NAVAJO TRIBAL UTILITY AUTHORITY  
AN ENTERPRISE OF THE NAVAJO NATION

SUBJECT: ADDENDUM #1 NOTICE

Let this memorandum serve as a notice of updated information regarding the “IP-CCTV & IP-Access Control for Window Rock WWTP”.

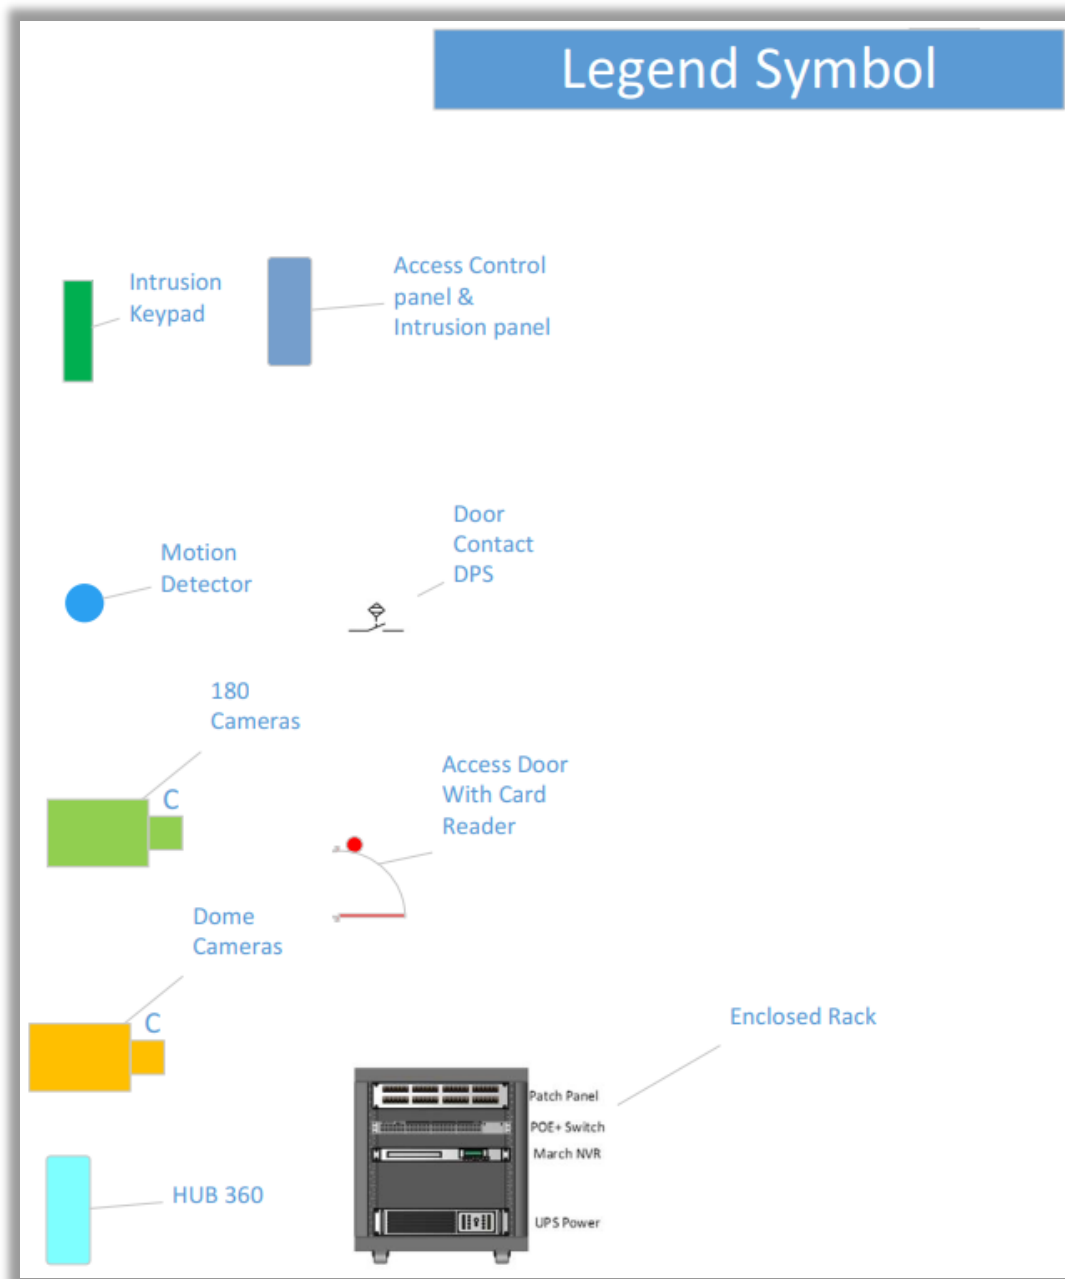
2. **Question:** On page 17, the drawing on the right is confusing. Are all these devices in the system or are some of them example symbols. The keypad, Access Control Panel, a couple of cameras on the right half of the drawing are in the middle of the room, so I am unsure.

**RESPONSE:** The drawing has been updated (included in this addendum).

## Window Rock WWTP - Garage

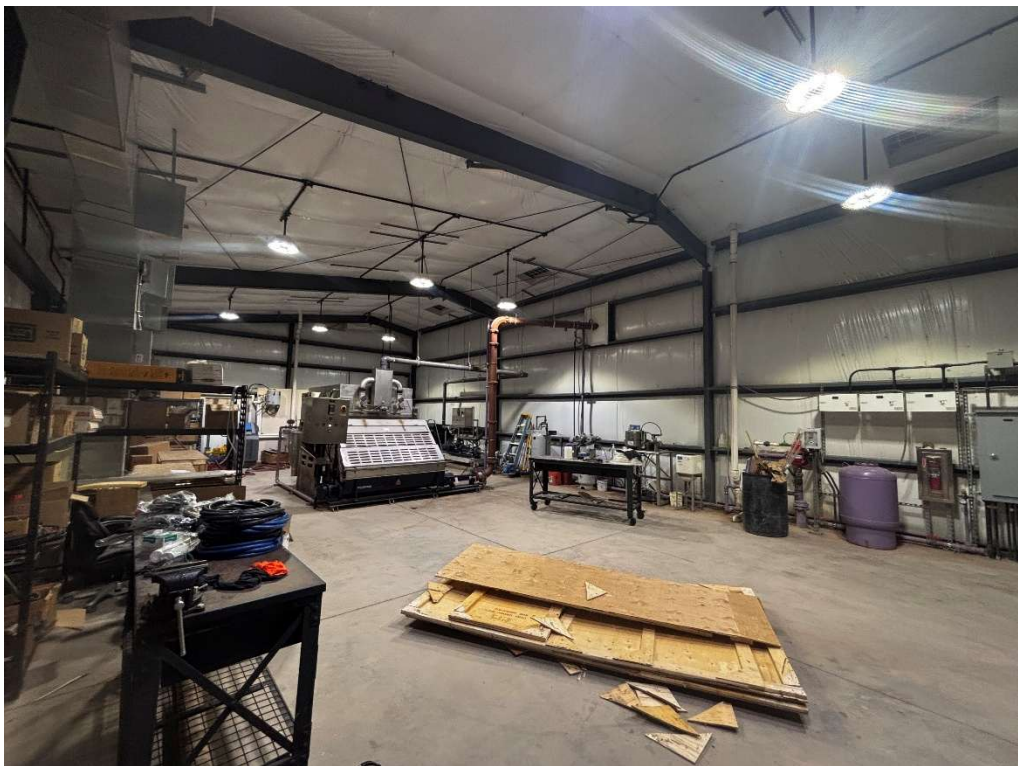
3. **Question:** What is the ceiling height and interior of these buildings like? Are there any photos of these buildings both interior and exterior?

**RESPONSE:** Ceiling height of the main building is 8ft4inches.
